RE: **Lot 23 Block 6 Volcano Cliffs Unit 18 SAD 228**
6511 Pato Rd. NW
Grading and Drainage Plan
Engineers Stamp Date 4/19/2025 (D10D003M23)
Pad Certification Date 8/6/2025
Case # HYDR-2025-00279

ENGINEER'S SEAL	LOT 23 BLK 6 U 18 VC 6511 PATO ROAD NW	DRAWN BY DEM
	GRADING AND DRAINAGE PLAN	DATE 4-18-25
4/19/25		SHEET # C1
DAVID SOULE P.E. #14522	PO BOX 93924 ALBUQUERQUE, NM 87199 (505) 321-8099	JOB #

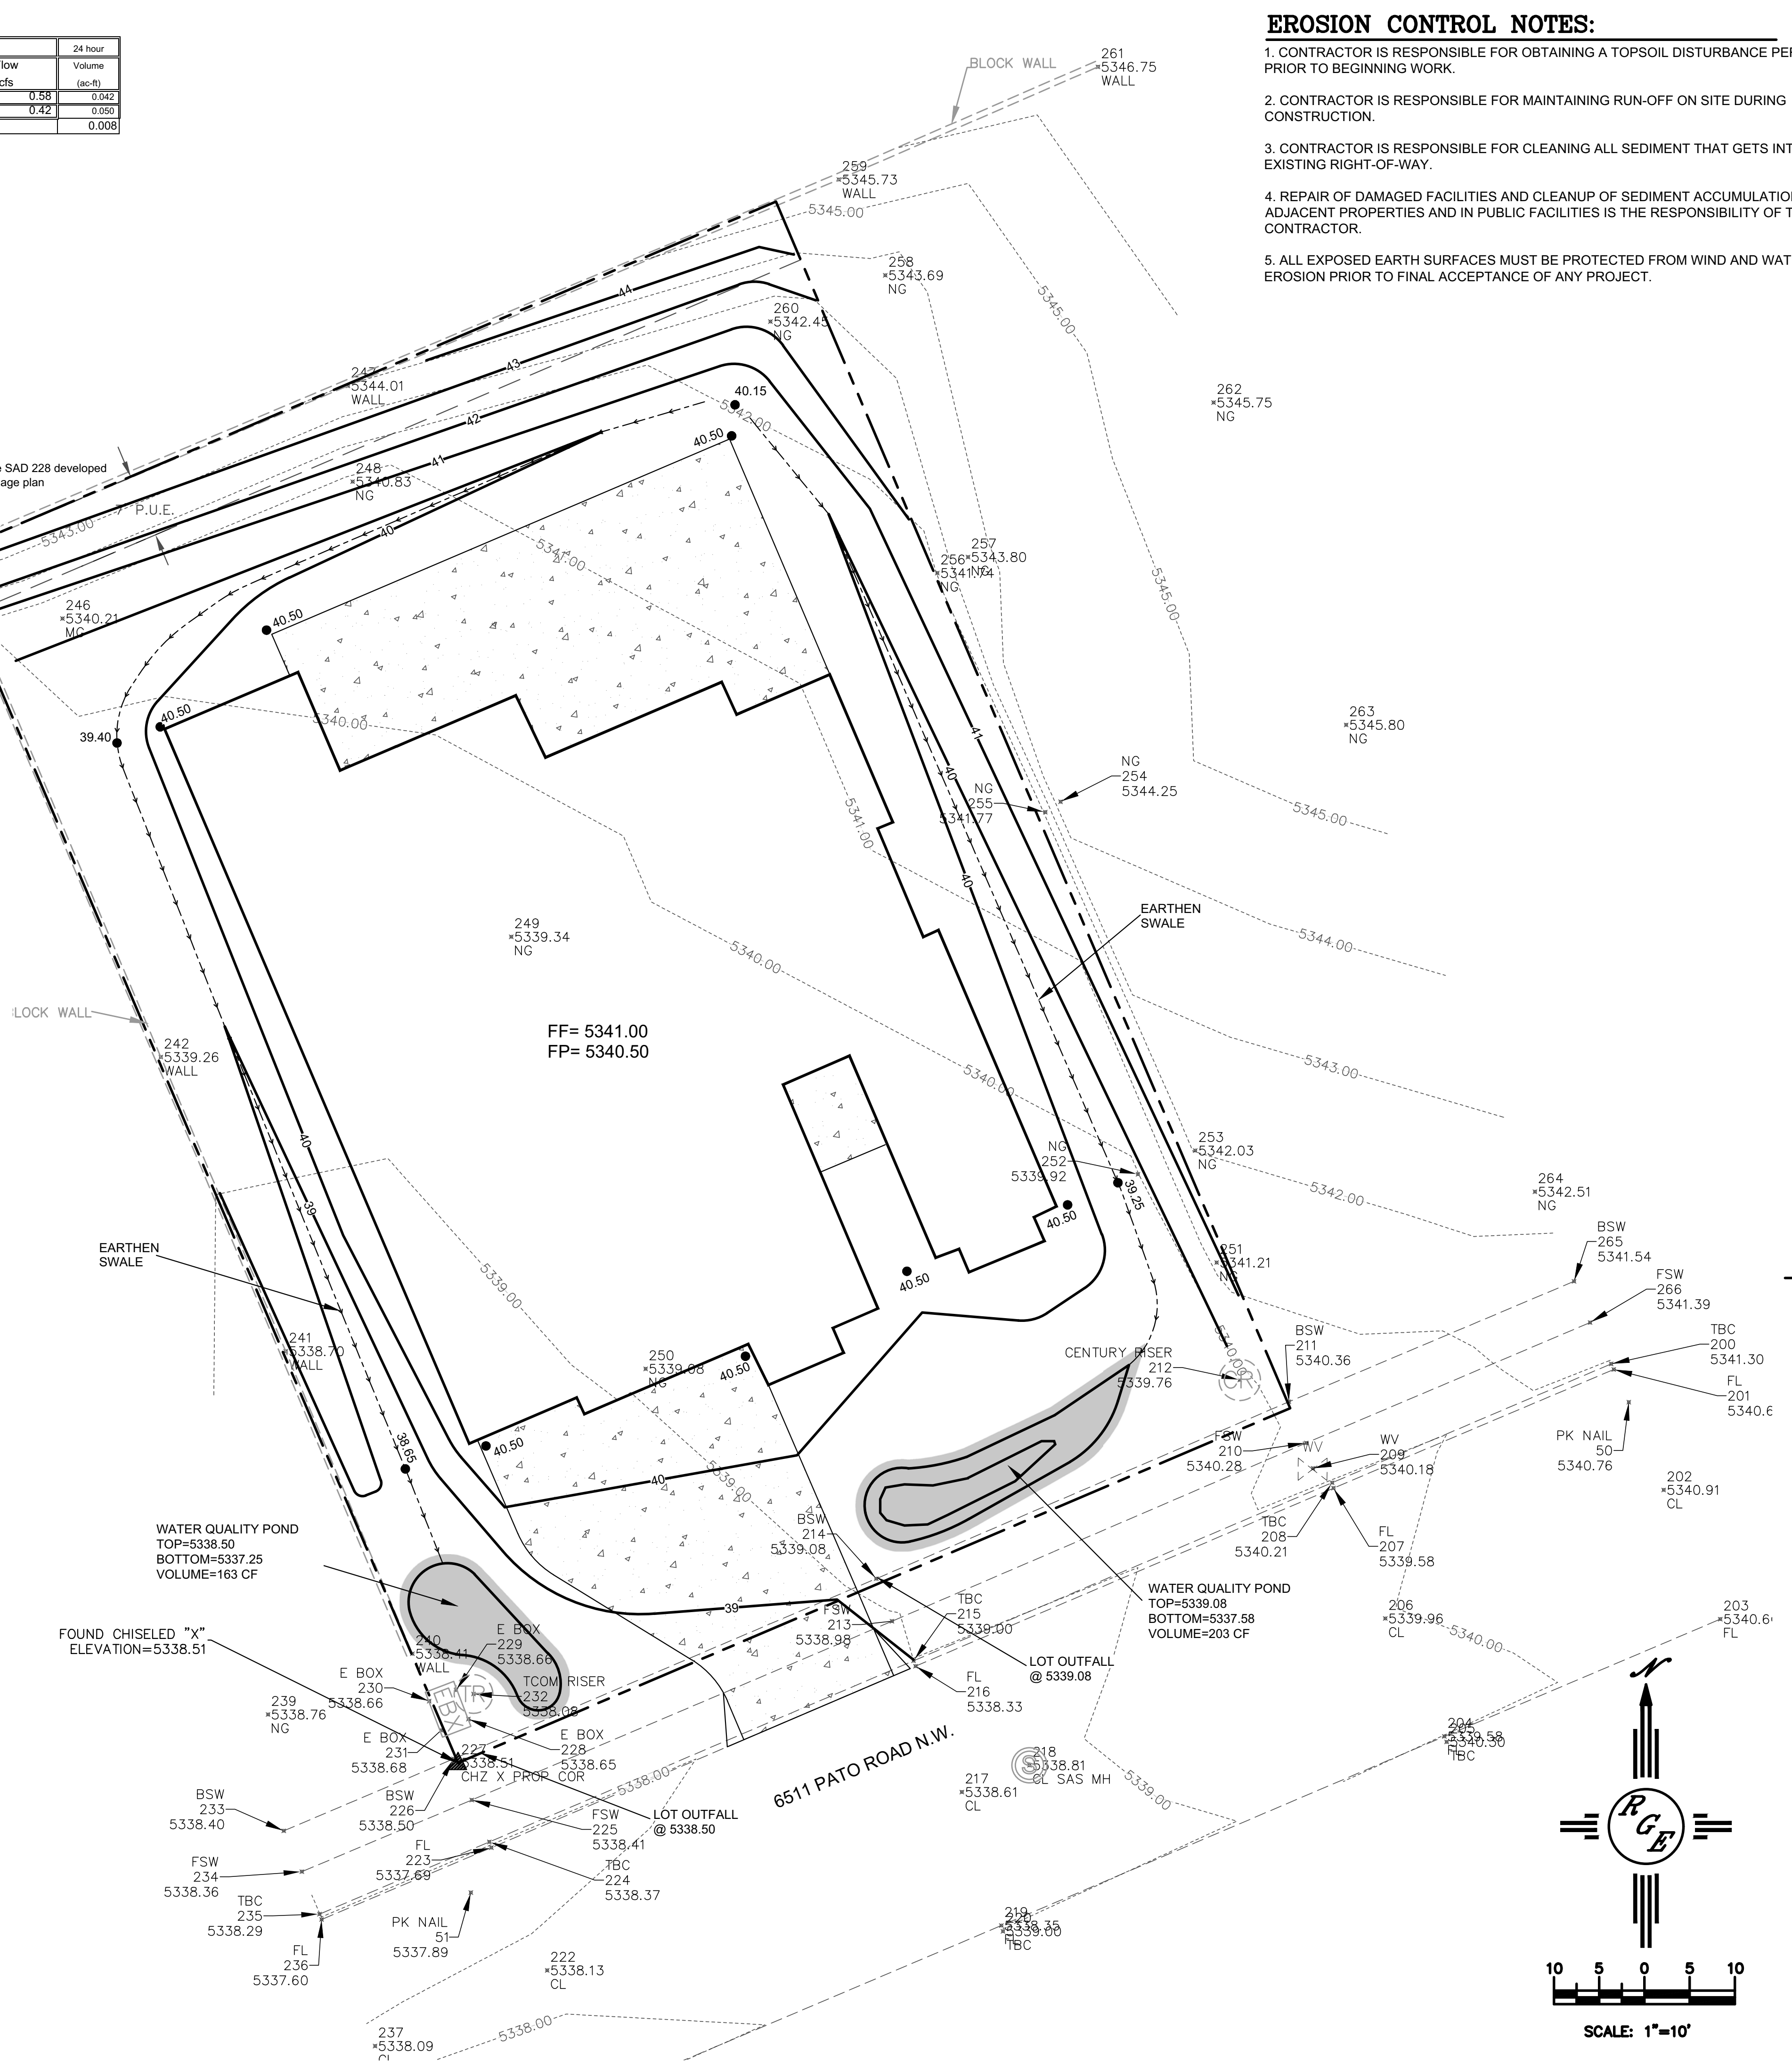
Based upon the information provided in your submittal received 8/11/2025, this plan is approved for building permit.

Reiterate to the Owner/Contractor that a separate permit for a garden/retaining wall must be obtained, with the approved G&D plan and Pad Certification. Advise the owner & Contractor that dirt is not allowed in the public right of way to climb the curb. Crusher fines or lumber is allowed. If dirt is used this will delay going forward with the construction of the home.

Prior to Certificate of Occupancy release, Engineer Certification per the DPM checklist of this plan will be required.
